# Enclosure A: List of Conditions for the Temporary DPR WTP

# Enclosure A
# List of Conditions, June 27, 2014
# City of Wichita Falls - PWS 2430001
# Temporary Direct Potable Reuse WTP - 410791

Subject: Public Drinking Water System Contact Time Study
City of Wichita Falls - PWS ID No. 2430001
Cypress 2010 Water Treatment Plant, TCEQ Plant ID No. TP410071
Wichita County, Texas

Subject: Public Drinking Water System Contact Time Study
City of Wichita Falls - PWS ID No. 2430001
Cypress Temporary Direct Potable Reuse Water Treatment Plant,
TCEQ Plant ID No. TP410791
Wichita County, Texas

**Use this worksheet to create your plant schematic with the Microsoft Drawing Tools.**
**If you are not familiar with the drawing tools, you may create your schematic using any other suitable medium.**
**Please refer to Section 3.3 of the Guidance Manual for instructions and guidance.**

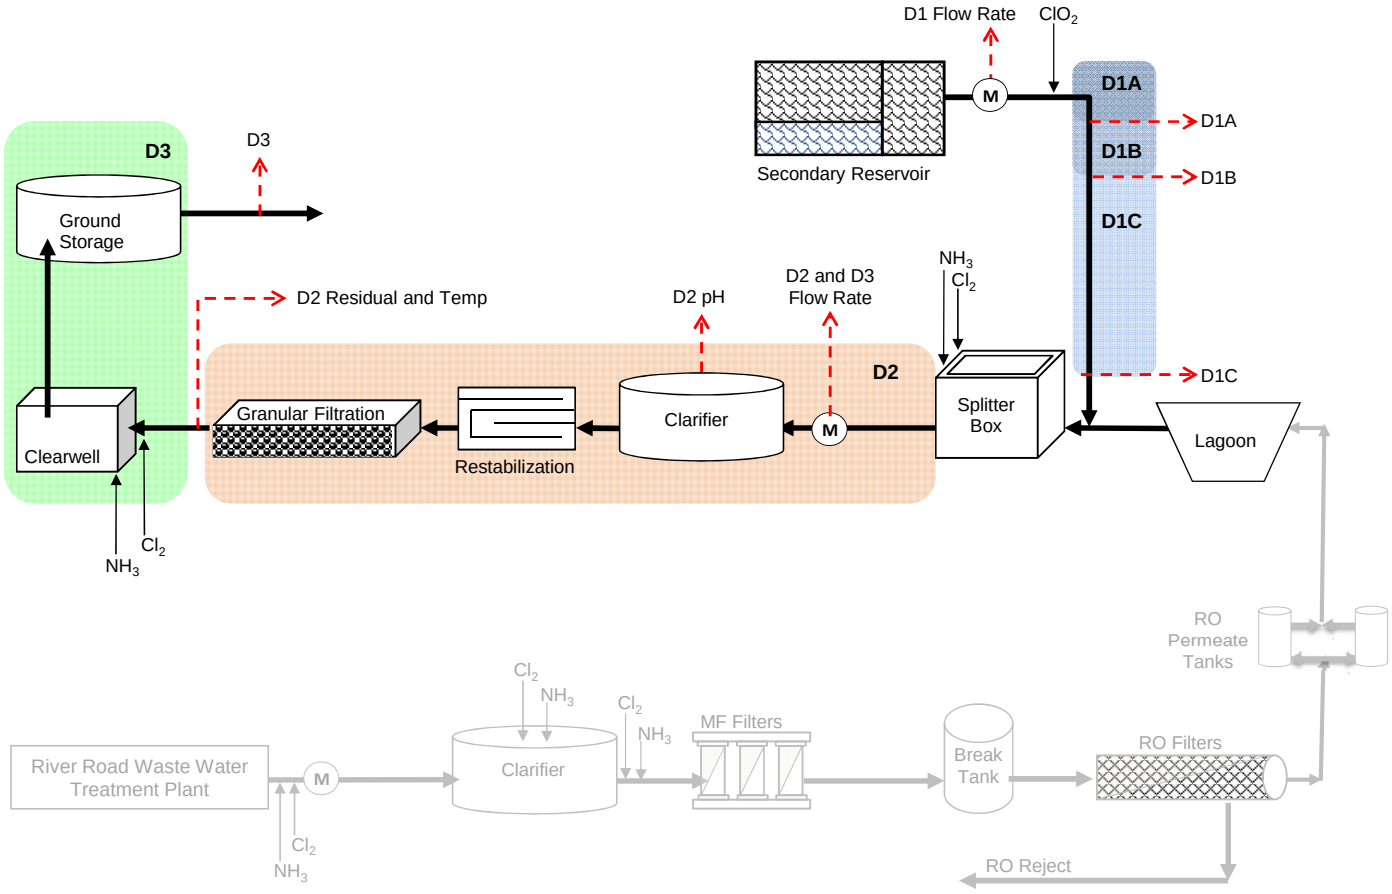
As you are aware, zone D2 includes the 2010 clarifier, recarbonation basin, and filters. As we have discussed, this grouping of treatment processes results in some constraints on the manner in which the plant can be operated and monitored. Specifically:

- **The operators must monitor the pH in disinfection zone D2 at the outlet of the 2010 clarifier.** Historically, the plant has practiced full lime softening and, therefore, the clarifier has operated at a higher pH range in order to achieve greater hardness reductions and improved total organic carbon removal. During the temporary DPR project, the 2010 Cypress WTP expects to meet these two treatment objectives by blending the surface water (from Lake Kickapoo and Lake Arrowhead) with RO permeate produced by the 2008 Cypress MF/RO WTP plant. However, the City would like to retain the flexibility to practice partial lime softening when conditions warrant.

- **The operators must have at least four filters in operations whenever the plant is treating water.** This operational constraint is needed because zone D2 contains both the plant's gravity filters and the disinfection contact time within the zone depends on the flow rate of the water and the total volume of water contained in the treatment units. Consequently, the CT calculations will overestimate the level of viral inactivation achieved if fewer than four filters are on line whenever the plant is treating water.

**Use this worksheet to create your plant schematic with the Microsoft Drawing Tools.**
**If you are not familiar with the drawing tools, you may create your schematic using any other suitable medium.**
**Please refer to Section 3.3 of the Guidance Manual for instructions and guidance.**

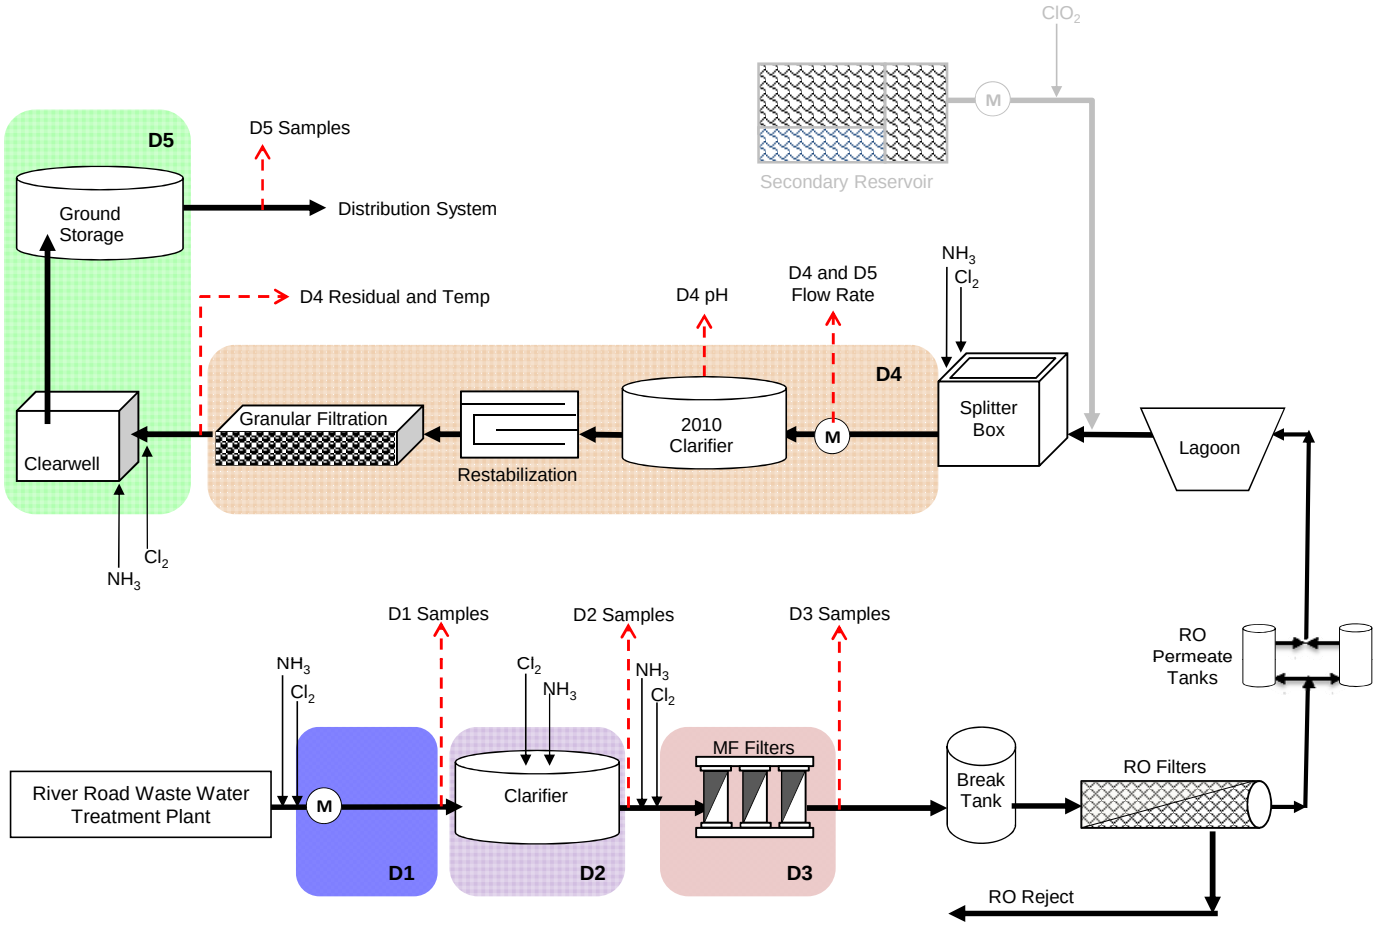
As you are aware, zone D4 includes the 2010 clarifier, recarbonation basin, and conventional filters. As we have discussed, this grouping of treatment processes results in some constraints on the manner in which the plant must be operated and monitored. Specifically:

- **The operators must monitor the pH in disinfection zone D4 at the outlet of the 2010 clarifier.** Historically, the 2010 Cypress WTP has practiced full lime softening and, therefore, the clarifier has operated at a higher pH range in order to achieve greater hardness reductions and improved total organic carbon removal. During the temporary DPR project, the Temporary DPR WTP expects to meet these two treatment objectives by blending the surface water (from Lake Kickapoo and Lake Arrowhead) with RO permeate produced by the 2008 Cypress MF/RO WTP plant. However, the City would like to retain the flexibility to practice partial lime softening when conditions warrant.

- **The operators must have at least four filters in operations whenever the plant is treating water.** This operational constraint is needed because zone D4 contains both the plant's gravity filters and the disinfection contact time within the zone depends on the flow rate of the water and the total volume of water contained in the treatment units. Consequently, the CT calculations will underestimate the level of viral inactivation achieved if fewer than four filters are on line whenever the plant is treating water.
